SITE PLAN REVIEW

LOT NO 51 REGISTERED PLAN 43M-1981

Client
Project Name
OSTIENSE
CITY OF BRAMPTON

Sheet Title
SITING
MARTIN BRYNE DRIVE
LOT 51
PLAN NUMBER
43M-1981

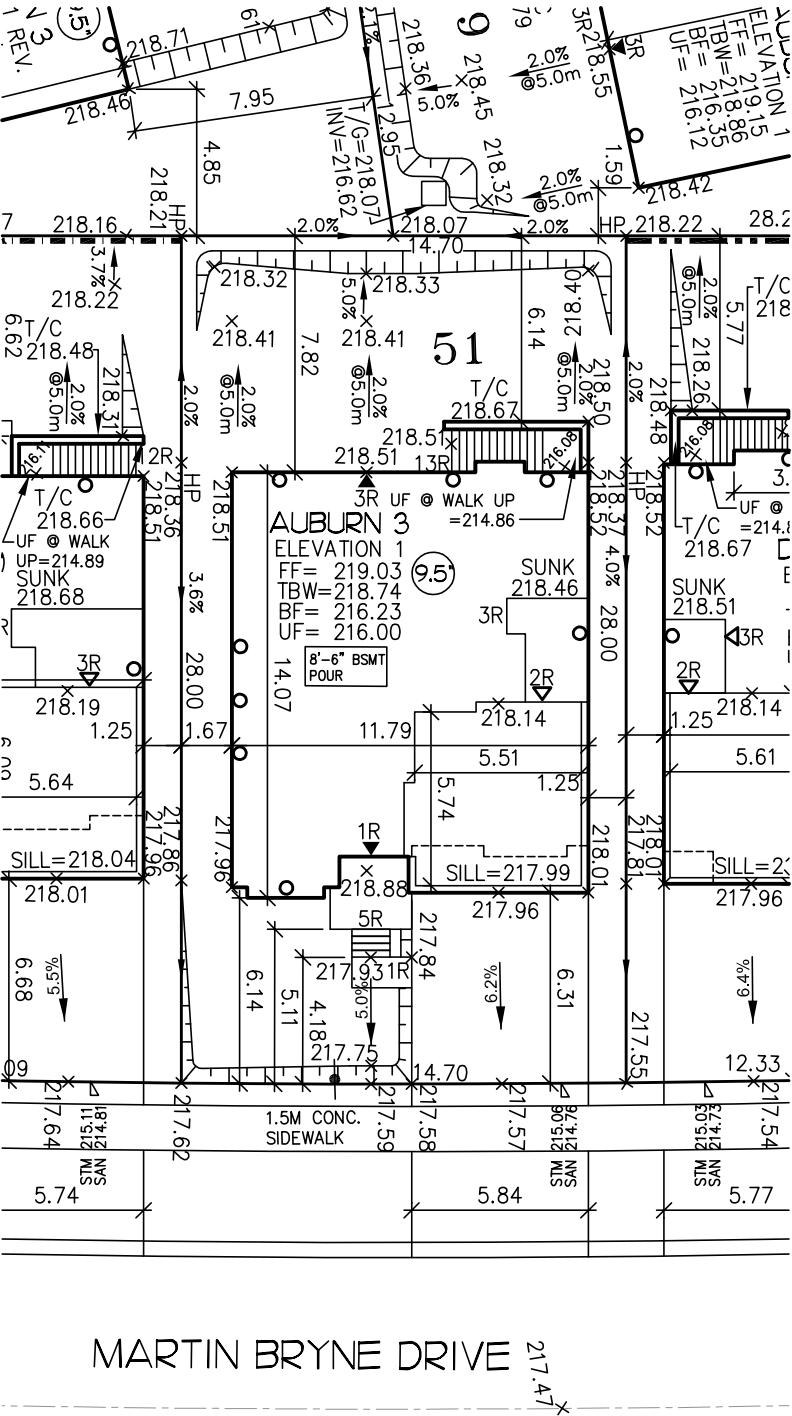
THE PROPOSED LOT GRADING AND DRAINAGE IS APPROVED AS BEING IN CONFORMITY WITH THE OVERALL APPROVED GRADING PLANS FOR THE SUBDIVISION.
